**Carlyle/Eisenhower East Design Review Board
September 18, 2007**

REQUEST: Approval for the parking garage treatment/screening.

LOCATION: Carlyle Plaza, 1800 Eisenhower Avenue (Block P)

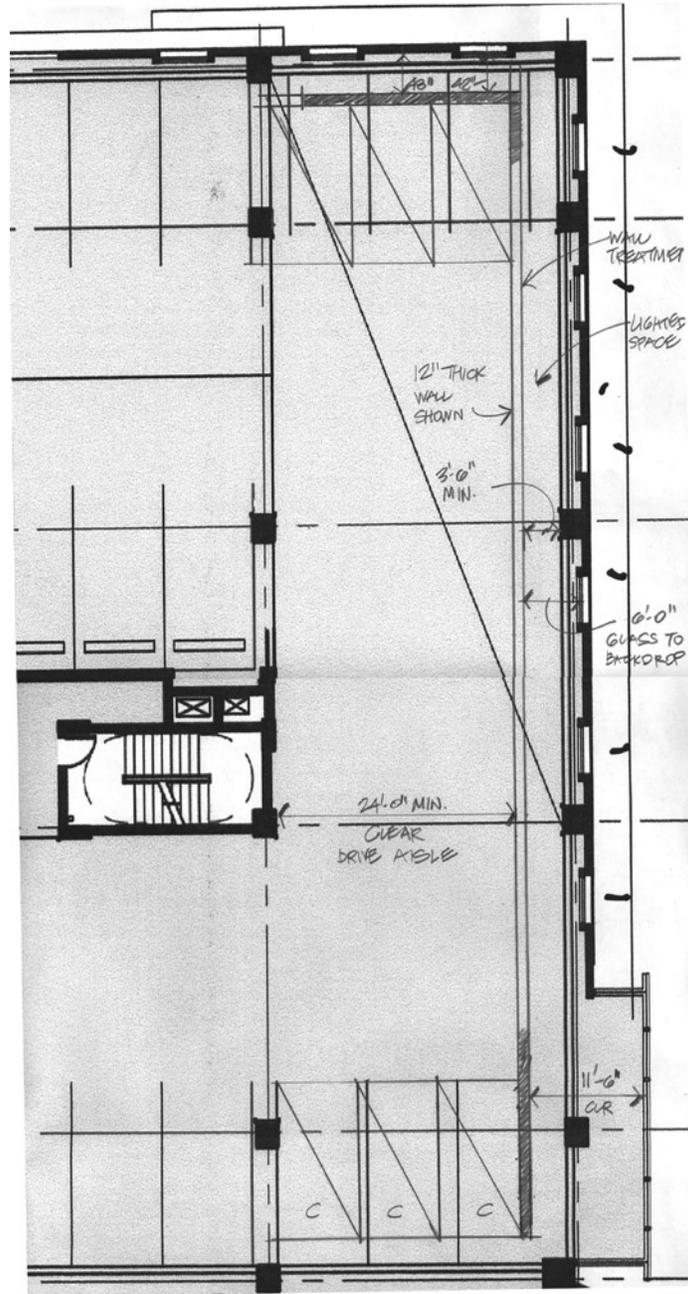
The impact of the parking garage on the Eisenhower Avenue façade is more severe. Sheets 15 and 16 illustrate that nearly 45 feet of vertical garage wall fronts Eisenhower Avenue. In the partial view on sheet 16, there is a sense of the grilles overwhelming the office glazing, which doesn’t start until nearly 65 feet above the sidewalk. Staff recommends that the applicant study treating at least two levels of garage facing Eisenhower Avenue with some application involving glass, and also present an option showing the effect of the new grille design if the tapered pier design were retained. Staff notes that along Eisenhower Avenue, there is adequate space in the existing building to accommodate a setback of garage functions from 6 to 11 feet behind a glazed façade (Attachment

A.) Moreover, glass is already used for garage screening in a number of locations (the northeast and southeast glass accent towers, and the entire first garage level along John Carlyle Street), so such an application could not be considered inconsistent with the design of the building.

Staff is recommending deferral of the proposed screening of the parking garage contingent on the applicant responding to the request of the Board and staff to prepare at least one alternative depicting glass for some elements of the proposed parking garage screening, especially for the Eisenhower Avenue façade. Staff acknowledges that the applicant has refined the screening of the garage and the base of the building, all of which have been positive refinements to the proposal. However, the current design, especially on Eisenhower Avenue, does not in staff’s opinion comply with the intent of the Design Guidelines which require that the parking structure “...*shall be treated with high quality materials to appear as an extension of the building(s) and that openings - fenestration shall be comparable to the building.*” Staff is also recommending that a color perspective be prepared for the Eisenhower Avenue elevation prior to approval by the Board. Staff recommends deferral of the garage screening for additional restudy, subject to the following:

1. The applicant shall submit a study for screening of the parking garage with glass or glass elements integrated with the proposed metal screening, with particular emphasis on the Eisenhower façade. In addition, as part of the parking garage screening, the applicant shall submit color street level perspectives showing the project as seen from northeast and northwest along Eisenhower Avenue. The treatment of the parking garage shall be restudied to consider the previously approved tapered precast piers option and the northernmost three bays along Hooff’s Run Dr.
2. The decorative grilles in the façade openings at the roof level of the north building shall be eliminated, per previous staff and DRB recommendations.
